REMARKS

This Amendment is submitted in response to the Office Action dated March 15, 2001. In the Office Action, the Examiner rejected claims 1-23. With this Amendment, new claims 24-43 are added; no claims are canceled; and claims 3, 4, and 10 are amended. Upon entry of this Amendment, the above-identified application will include claims 1-43.

Fig. 8

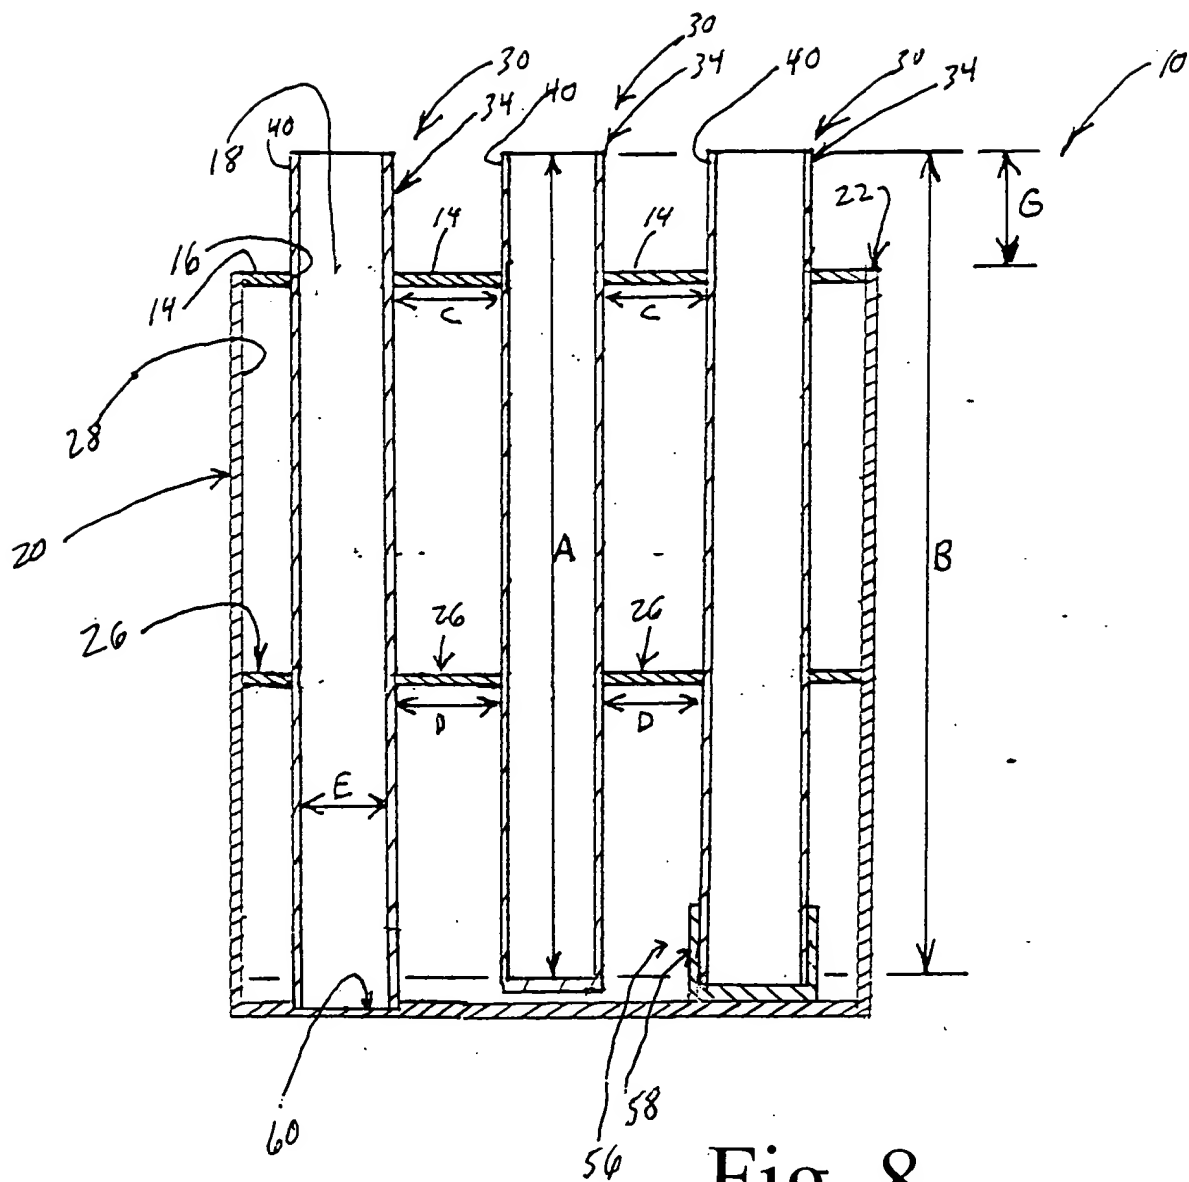
In the Office Action, the Examiner objected to the drawings under 37 C.F.R. § 1.83(a). In support of this objection, the Examiner stated:

“The drawings are objected to under 37 CFR. 1.83(a). The drawings must show every feature of the invention specified in the claims. Therefore, the spacing structure, recesses, sockets, first spacing component, second spacing component, and legs must be shown or the feature(s) canceled from the claim(s). No new matter should be entered.”

described in the specification as permissibly being the legs of concern to the Examiner. (See page 5, lines 16-21 and lines 25-27 of the above-identified application). Finally, Applicant has added new Figure 8 that depicts the recesses of concern to the Examiner at 60 and the sockets of concern to the Examiner at 58.

Then, Applicant directs the Examiner's attention to new Figure 8 and the amended paragraph added in place of the original paragraph at page 13, lines 3-14, where details about the recesses and sockets are provided. Applicant notes that details about these recesses and sockets were also provided in the first paragraph on page 13, at lines 3-14, of the above-identified application, as originally filed.

--Figure 8 is another sectional view of the ice fishing tackle storage apparatus depicted in Figure 3, taken through line 3-3.--

As another option, a positioning flange[s (not shown)] 56, such as a socket[s (not shown)] 58, that [are] is capable of accepting and securing the distal ends 38 of the tubes 30, as best depicted in Figure 8, may be fixed to the bottom wall 25 of the container 12, in lieu of the template 26, when the template 14 is used. The flange[s] 56, in combination with the template 14, helps to stabilize and maintain a particular desired alignment between different tubes 30. As another alternative, the templates 14, 26 may each be dispensed with, in favor of [the] positioning flanges 56 or sockets 58 only, by increasing the height of the positioning flanges 56 or sockets 58 to grip more of the length of the tubes 30. As yet another alternative, a recess[es (not shown)] 60 may be bored or formed in the bottom wall 25 of the container 12 to accept the distal ends 38 of the different tubes 30, in place of using the positioning flanges 56 or the template 26 for purposes of stabilizing the tubes 30.
